CITY PLANNING COMMISSION

- APPLICATION:
1. Negative Declaration
 2. Amendment of South Natomas Community Plan from Residential (11-21 du/ac) to Residential 4-21 du/ac) (WITHDRAWN)
 3. Amendment of the South Natomas Community Plan to allow single family front-on lots on Truxel Road
 4. Rezone from Townhouse-Review (R-1A-R) to Garden-Apartment-Review (R-2B-R) and Medium Density Multiple Family-Review (R-3-R)
 5. Establishment of a PUD Schematic Plan known as Pheasant Creek
 6. Special Permit to develop a 215 unit condominium project
 7. Tentative Map (P83-327)

LOCATION: Northeast corner of Truxel Road and West El Camino Avenue

APPLC. NO. P83-327

PHEASANT CREEK

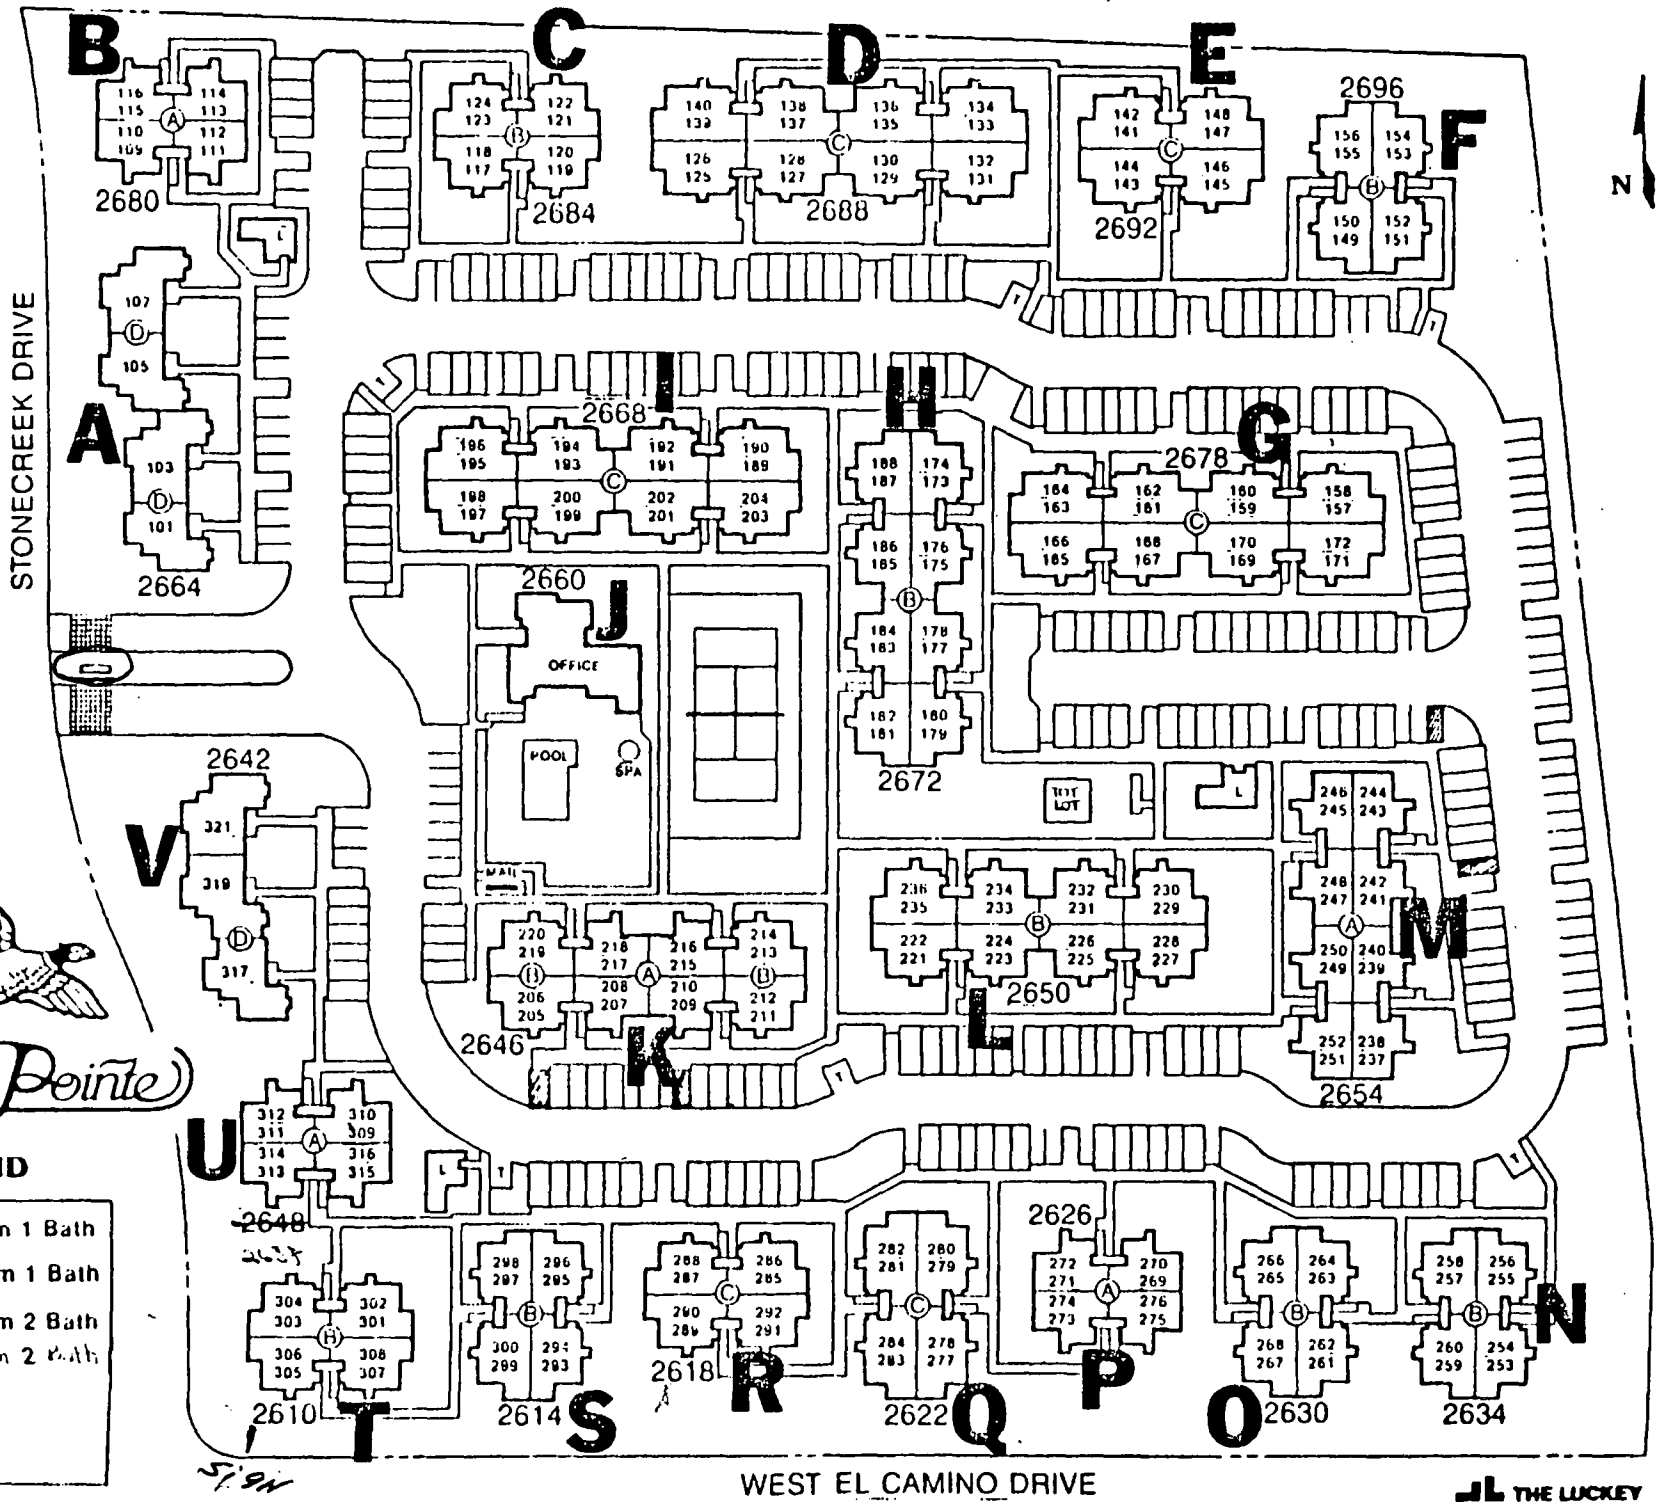
- A. The applicant is requesting the necessary entitlements to develop a 215 unit condominium project on this site. As proposed, this development will provide for two and three bedroom units ranging in size from 600 square feet to 1,188 square feet. The structures consist of primarily two story clusters constructed with vertical wood siding and asphalt shingles. To the east of this site is an existing single family subdivision.
- B. Staff is not opposed to the overall density of this condominium project. However, staff does have some concerns relative to the high percentage of one bedroom units and two story structures, the site design adjacent to the single family subdivision, and the exterior elevations.

To provide a buffer between the existing single family residences staff recommends that a minimum setback of 50 feet be adhered to for two story

structures and a minimum setback of 20 feet for one story structures along this property line. Furthermore, staff recommends that a six foot masonry wall be required along the easterly property line between the proposed project and the adjacent single family subdivision.

Staff notes that recent proposals for multiple family projects in the South Natomas area have been lacking adequate design consideration. Staff finds that this project also lacks in design consideration. Therefor, as a condition of approval, staff recommends that the project be subject to review and approval of the Design Review Board. Staff also recommends that the Board review the project in consideration of requiring variations in building heights, exterior materials and the addition of such enhancements as balconies, eave overhangs and additional trim.

- b. The applicant shall submit a detailed landscape and irrigation plan for staff review and approval. This plan shall include adherence to the criteria listed in the PUD Guidelines.
- c. A minimum setback of 50 feet shall be adhered to for two story structures and a minimum setback of 20 feet for one story structures along that portion of the project abutting the single family development to the east.
- d. A six foot masonry wall shall be erected between the proposed parking lot adjacent to the existing single family development.
- e. A revised site plan shall be submitted to staff for review and approval prior to issuance of building permits.

Exhibit "B"

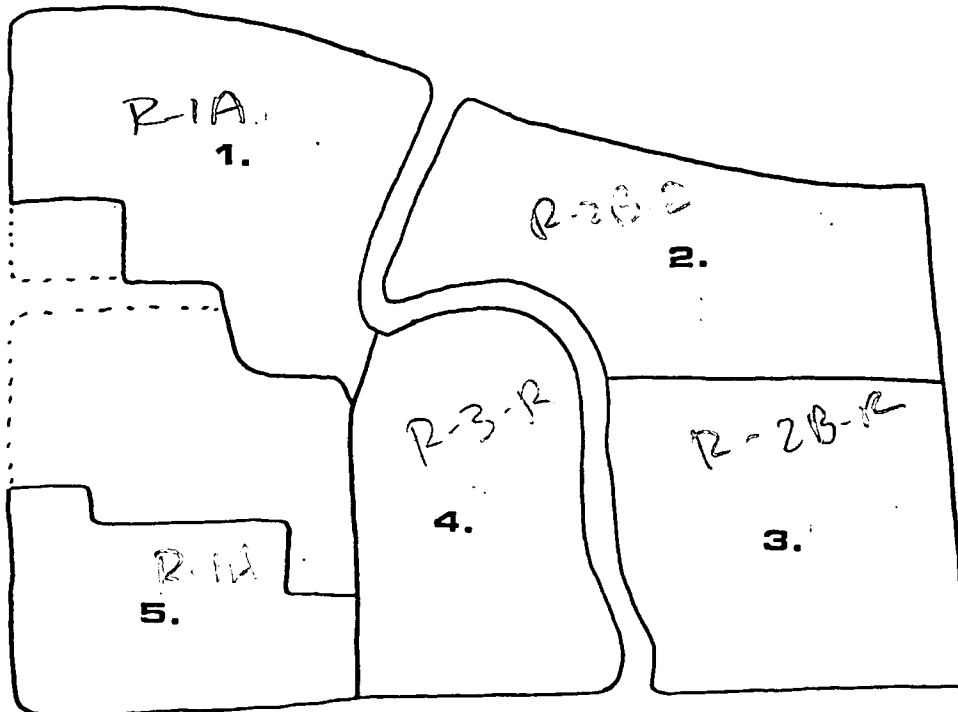
- A. The South Natomas Community Plan designates the southwesterly portion of the site (site 5) as 11-21 units per acre and the remainder of the site 4-21 units per acre/7 units minimum average. Therefore the overall development of the PUD cannot exceed 21 units per net acre. As proposed, the overall density, at 19.6 units per net acre, complies with these designations.

- B. The applicant proposes to develop five different residential sites for condominium, apartment, and zero lot line units. The plan is designed in a logical pattern with the higher densities condominium and apartment units located along the El Camino Avenue frontage and the lower densities zero lot line and garden apartment units located adjacent to Brewerton Drive. This provides a logical transition to the existing single family subdivision to the north.

- C. Among the requested entitlements is a Community Plan Amendment to allow frontage lots on Truxel Road. Currently, City staff is reviewing subdivision design standards for major streets. Thus far this study has indicated that front-on lots can be workable given larger than normal lot sizes. Staff, therefore, does not object to this amendment as long as the design standards indicated in exhibit G are adhered to.

- D. Staff has no objection to the overall density or the relationships between the proposed land uses. However, staff finds that there are many specific design elements that need to be incorporated into the project. Staff therefore recommends that the development and design criteria outlined in exhibit G be adopted as part of the PUD. These guidelines will then be utilized as each phase develops and special permits are obtained.
